ASSESSMENT REPORT

Ginkgo Mineral Sands Mine

Waste Management Modification

(DA 251-09-01 MOD 11)

Figure 3: Proposed On-site Landfill and Leachate Holding Dam

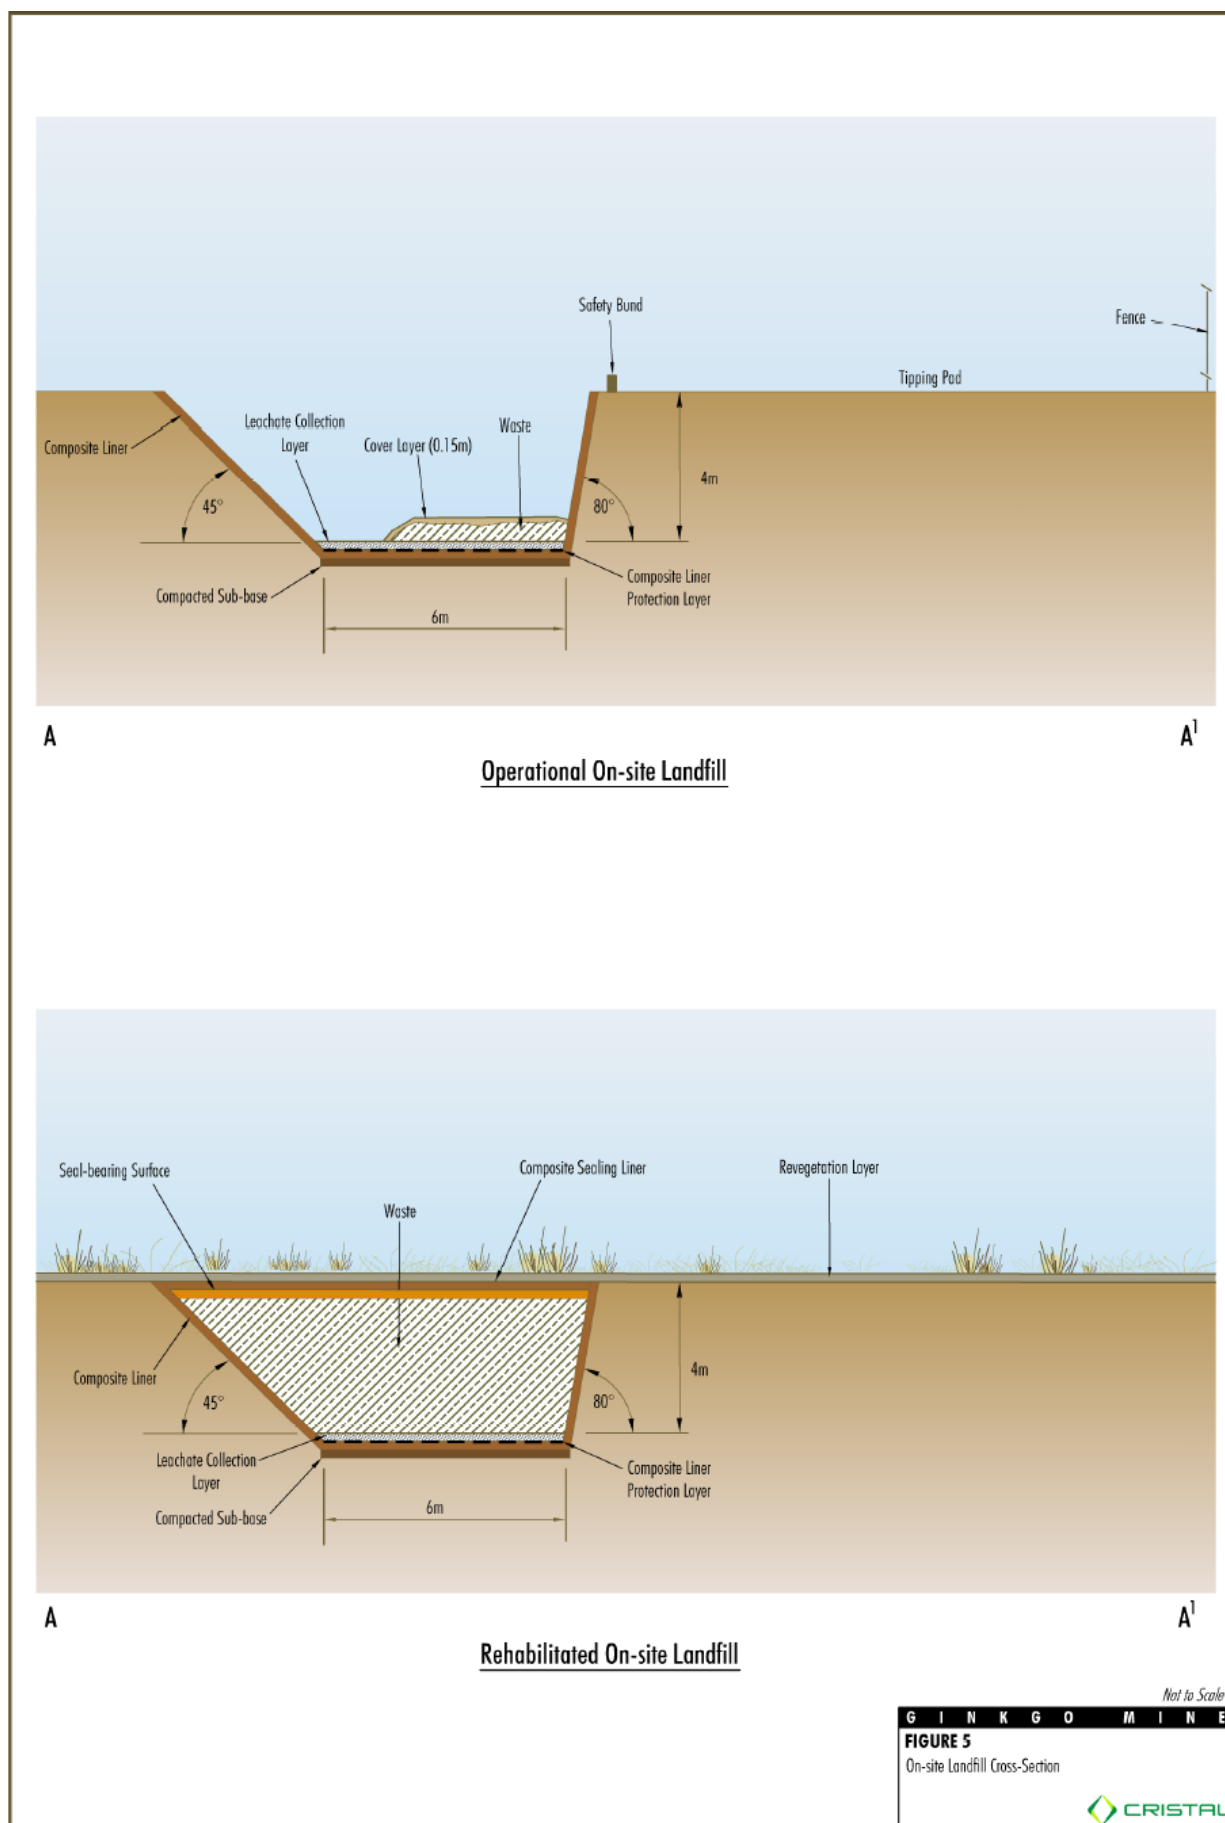
Department of Primary Industries (DPI Water) was satisfied there was low risk to the groundwater resource given the proposed design of the landfill and the leachate holding dam (including the leachate barrier system) and the continued implementation of Cristal's Borefield Impact Management Plan. DPI Water recommended monitoring of the proposed holding dam water level to ensure adequate freeboard is maintained at all times. DPI Water also recommended monitoring of the volume of pumped leachate from the landfill to identify any potential leakage from the barrier system and if necessary, the need for any contingency responses.

<i>Rehabilitation</i>	• The proposed rehabilitation of the landfill would include construction of a final capping layer comprising a 0.3 m thick seal-bearing surface overlain by a composite sealing liner beneath the revegetation layer (see Figure 2). This capping layer would be constructed to: – reduce rainwater infiltration into the landfill; – reduce sediment and contaminated runoff; and – minimise odour and gas.	
<i>Air Quality and Gas Emissions</i>	• Air quality impacts are already controlled under strict conditions of consent, and the EA considers that there would be no significant changes to air quality emissions from the proposed modification. Operational activities associated with the landfill would be minor in the context of the existing operations at the mine, and would be unlikely to result in any appreciable air quality impacts at sensitive receivers, the closest of which is located 10 km away from the site. • Gas production from the landfill would represent a low risk to the environment, health and amenity due to the small quantities of waste that would be disposed of and the minimisation of putrescible waste by composting. • Odour would be controlled by compacting each layer of waste and covering the compacted waste with a layer of soil 0.15 m thick. A 0.30 m layer of soil would be used to cover areas where no more waste would be applied. • Cristal would continue to manage air quality through its Air Quality Management Plan, which would be updated in accordance with existing conditions.	• No additional conditions are required to manage air quality impacts.

- an update to the Site Water Management Plan to include:
 - contingency plans to deal with leachate seepage;
 - monitoring of the pumped leachate volumes; and
 - monitoring of holding dam water levels;
- design, construction and operation of the landfill to be consistent with the EPA guideline document *Draft Environmental Guidelines: Solid Waste Landfills (EPA, 2015)*;
- the construction of the landfill and holding dam be verified by a suitably qualified engineer prior to commissioning; and
